1.0 Introduction

- 1.1 Following submission of planning application 5/2022/0599 to St Albans District Council, Hertfordshire County Council ("HCC") as Local Highway Authority ("LHA") submitted their consultation response dated 17th March 2022, within which a number of points were raised.
- 1.2 The development proposals comprise of up to 45 dwellings.
- 1.3 Discussions have been held with HCC highway authority regarding the comments relating to pedestrian access, vehicular access design and parking. This note therefore provides one single response to the consultation response and discussions with HCC to date. For ease, the comments of HCC are presented in *italicised blue text*.
- 1.4 The consultation response is attached in **Appendix A**. An updated access plan is attached at **Appendix B**.

Response to Planning application from Hertfordshire County Council (T and CP GDP Order 2015)

District ref: 5/2022/0599
HCC ref: SA/11502/2022
HCC received: 17 March 2022
Area manager: Mark Youngman
Case officer: Samuel Tearle

Figure 1 – Area of Car Parking Beat Survey

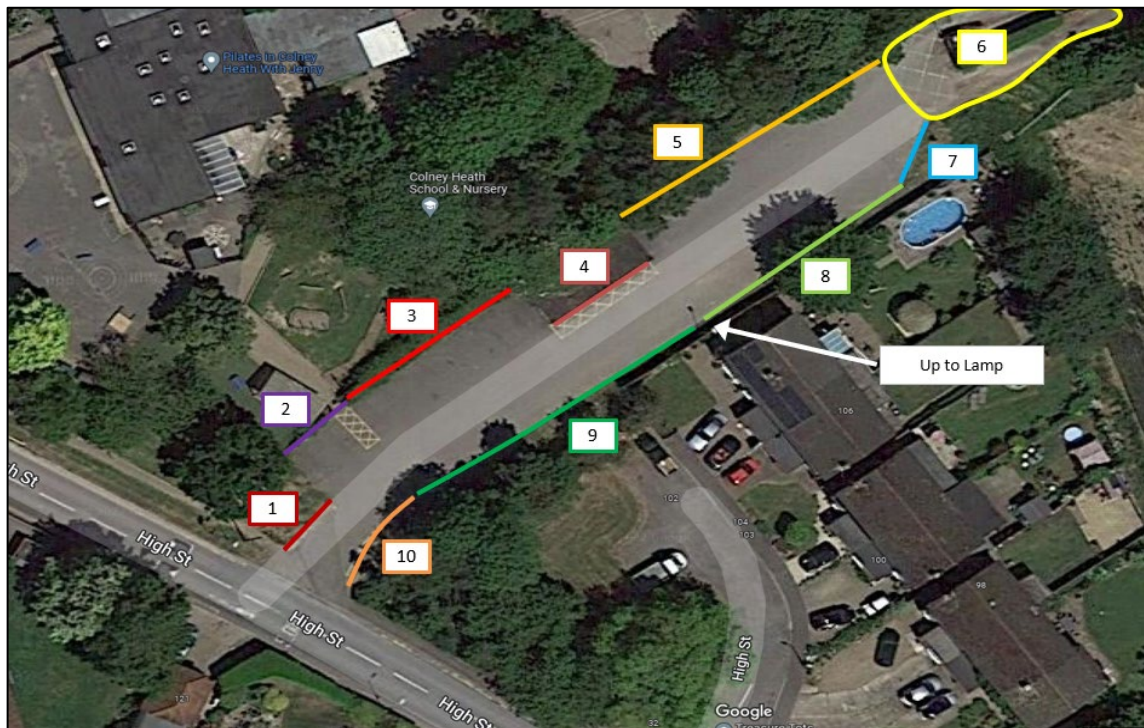
The Highway Authority are concerned the proposed changes to the private access road will lead to a displacement of 'unofficial' parking for Colney Heath School & Nursery and football club. No details of current usage have been provided and therefore the Highway Authority are concerned the displacement of parking may result in inappropriate and unsafe parking occurring on sections of the surrounding highway and footway network.

The applicant must submit additional details, including a parking survey during peak school times, that demonstrates the loss of potential parking area will have a negligible impact to safety.

- 4.1 A car parking beat survey was undertaken on the site access road on Thursday 28th April 2022 during school drop off/ pick up. The survey was undertaken for a 12-hour period from 07:00 to 19:00. A copy of the survey data is attached at **Appendix C**. The area surveyed is shown below.

4.2 The area surveyed had a total of 37 car parking spaces.

4.3 The results of the survey showed that peak parking demand in the morning occurred between 08:50 and 09:00 where there was a total of 34 cars parked at 08:50 and 32 cars parked at 09:00. In the afternoon peak parking demand occurred between 15:00 and 15:20 where there was a total of 24 cars parked at 15:00 and 34 cars parked at 15:10 and 15:20. It is noted that during these times parking was almost or at capacity.

- 4.5 The proposals for the scheme will result in the loss of parking areas 7 – 10 as shown on **Figure 1** above which equates to around 17 'spaces'. The parking areas in Zone 1-6 to the west of the access are under the ownership and control of the Parish Council and therefore no changes will be made to the existing parking arrangement at those locations.
- 4.6 The Applicant has been in discussions with the football club with regards to the use of the football club car park for 'unofficial' school drop off and pick up parking. A letter from the football club is attached at **Appendix D** which confirms that they have no objection to Colney Heath Primary School and Nursery using the football club car park for parents dropping off/ picking up children.
